DOCKETED	
Docket Number:	11-AFC-04
Project Title:	Rio Mesa Solar Electric
TN #:	233565
Document Title:	Applicant's Supplemental Response to Data Request 16 and 26 Additional Information Regarding Noise
Description:	Document was on proceeding webpage and is now moved over to the docket log.
Filer:	Marichka Haws
Organization:	California Energy Commission
Submitter Role:	Commission Staff
Submission Date:	6/19/2020 3:37:52 PM
Docketed Date:	6/19/2020

APPLICANT’S SUPPLEMENTAL RESPONSE TO DATA REQUEST 16 AND 26: ADDITIONAL INFORMATION REGARDING NOISE

In this section of Applicant’s Supplemental Response to CEC Staff Data Requests 16 and 26, Applicant describes the changes to the Noise section that will result from the changes to the Project Description relating to the removal of Unit 3 and the new schedule of operating equipment associated with the boiler optimization. Per staff’s request, Applicant uses a strike-out/underline format to identify changes to the Noise section of the Application for Certification that will result from the changes to the Project Description.

CREATED BY: DT	DATE: 6/27/2012	FIG. NO: 5.7-1
PM: AL	PROJ. NO: 27651003.40010	(REV)

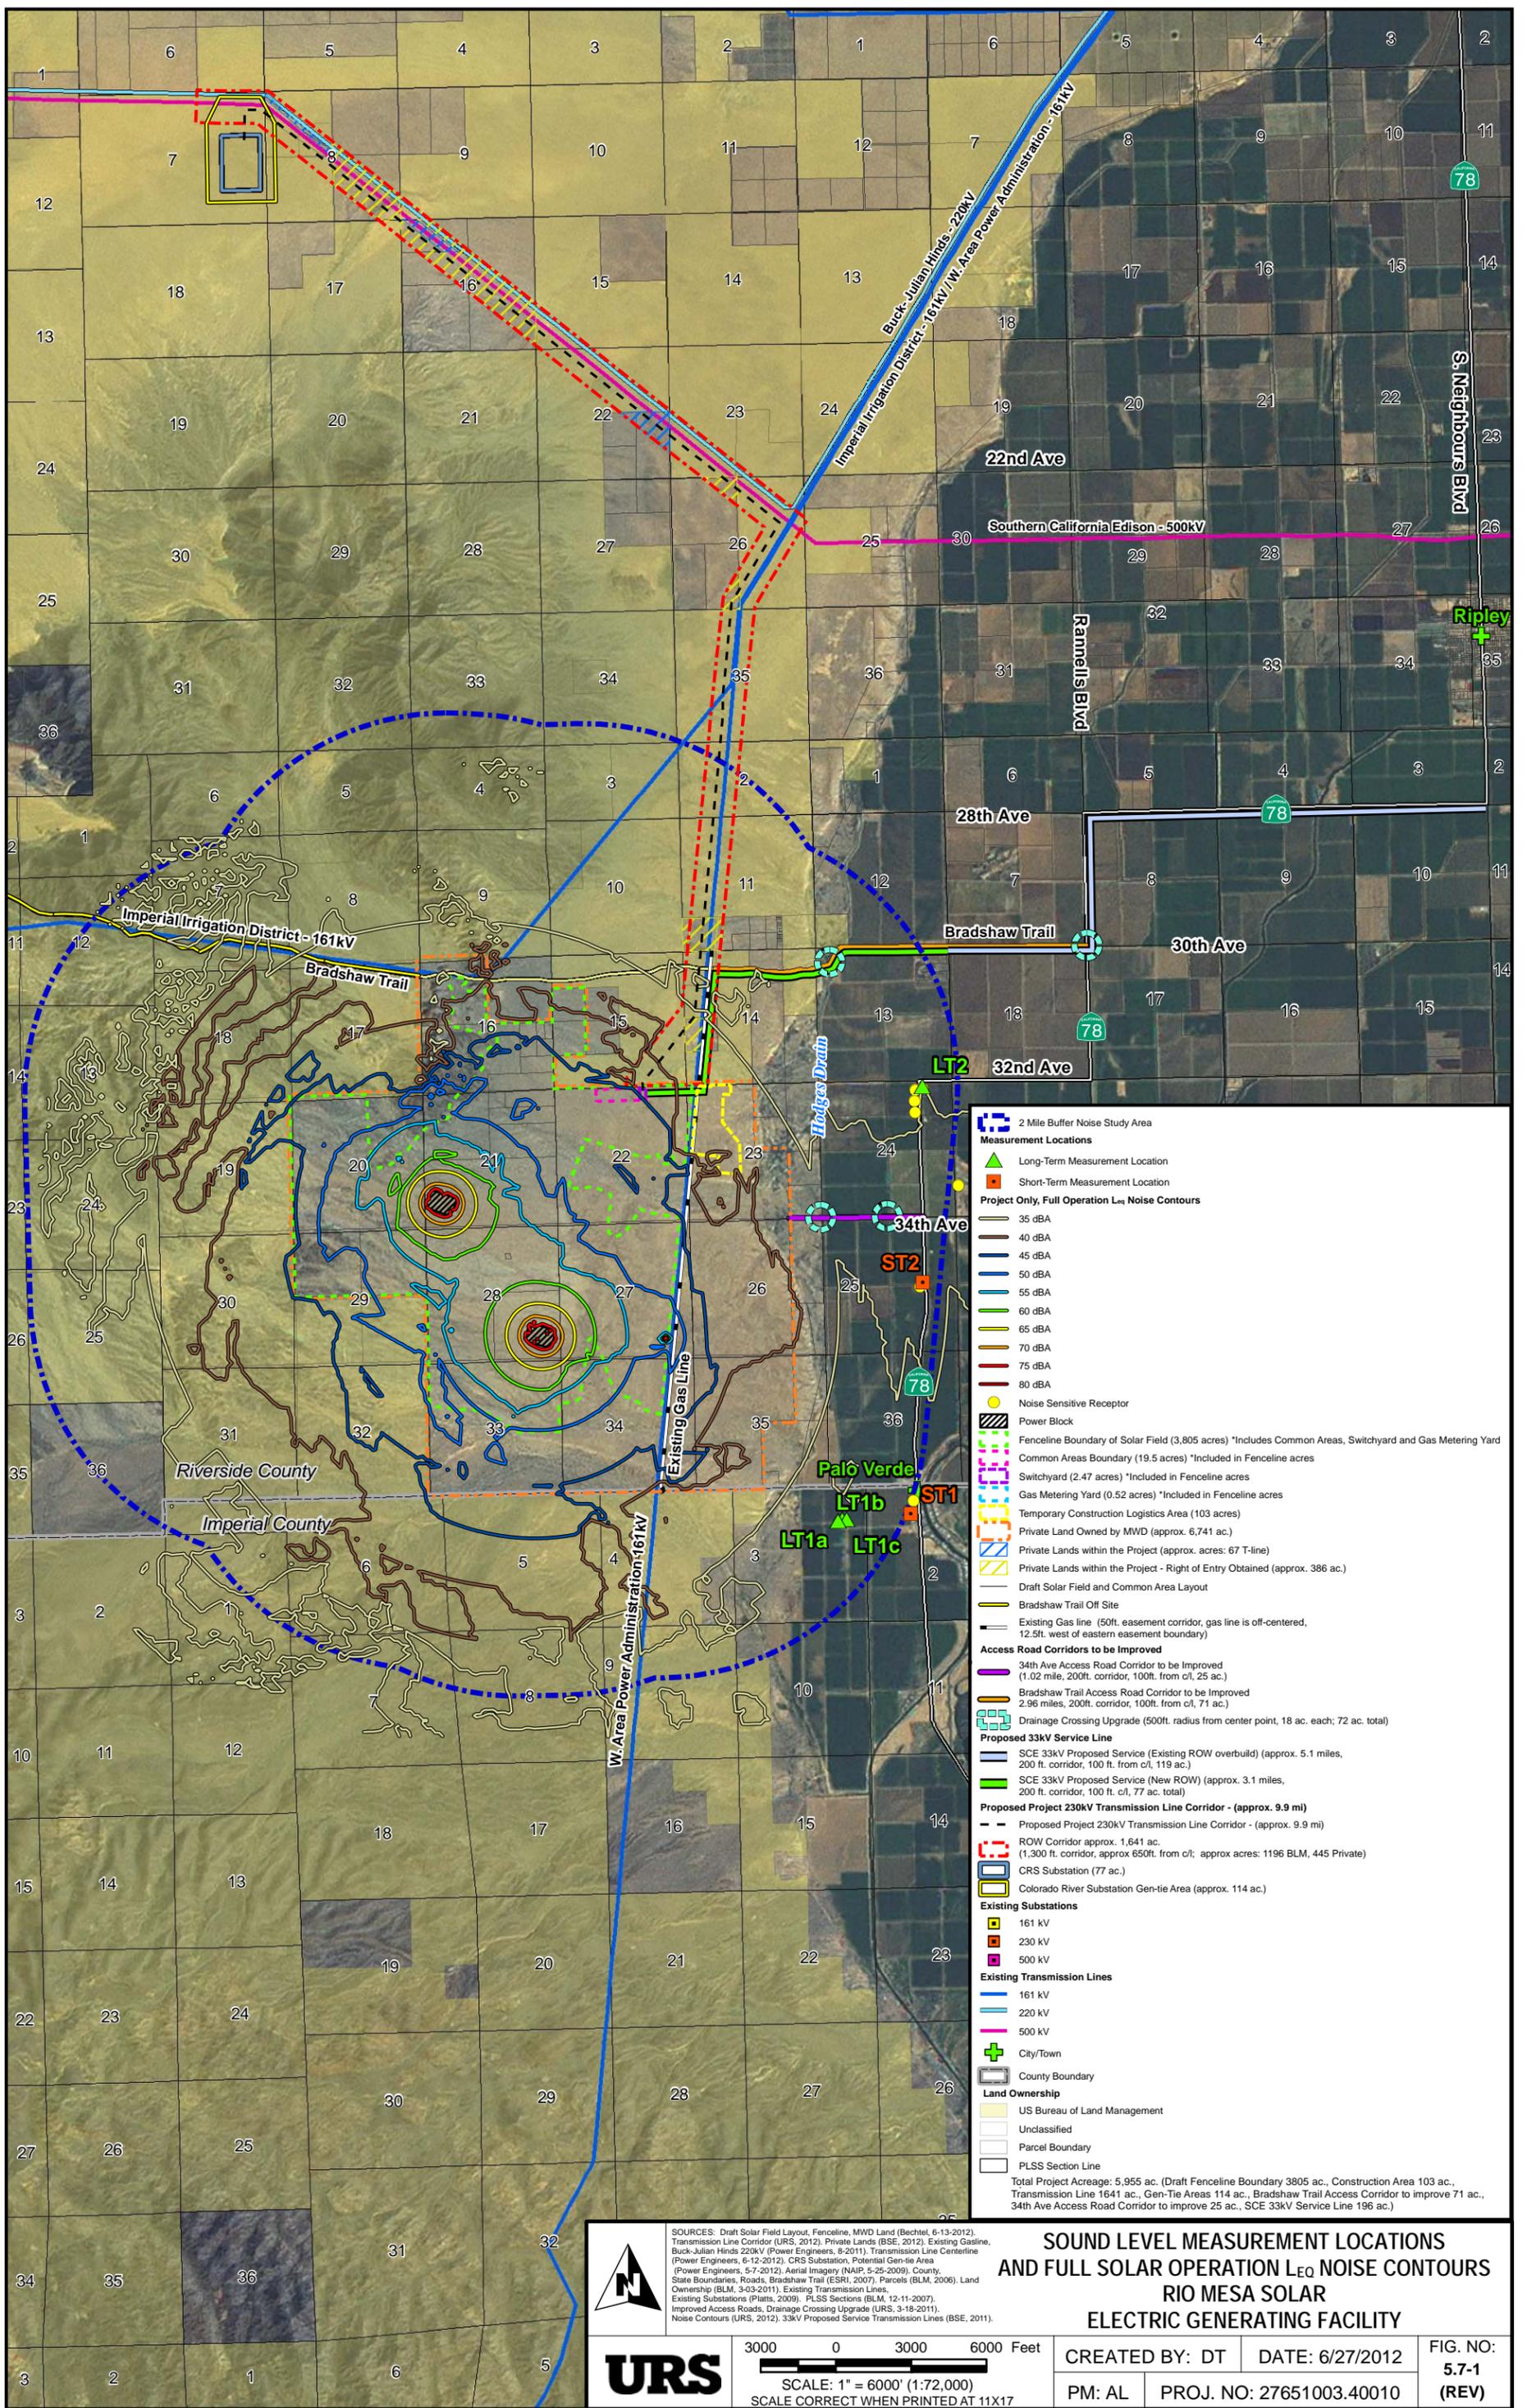
- Figure 5.7-1 [\(rev\)](#) Sound Level Measurement Locations and [Full Solar Operation \$L_{eq}\$ Noise Contours](#)
- [Figure 5.7-2 \(rev\) Sound Level Measurement Locations and Startup Operation \$L_{eq}\$ Noise Contours](#)

Predictive Cadna/A-based noise levels during “full” and “startup” operation [mode scenarios](#) are shown and included in Figures [5.7-1 and 5.7-2, respectively](#). The figures depicts [equal sound level isopleths or ~~dB level~~ contours](#) for the Project in decrements of five dB, at an assumed typical receptor height of [approximately](#) five feet. The results of the predictive Cadna/A-based calculations [at specific geographical locations](#) are summarized in Tables [5.7-13 and 5.7-14](#) and ~~are~~ compared against [measurements of](#) ambient noise levels [taken at these same locations as measured](#) during the summer of 2011.
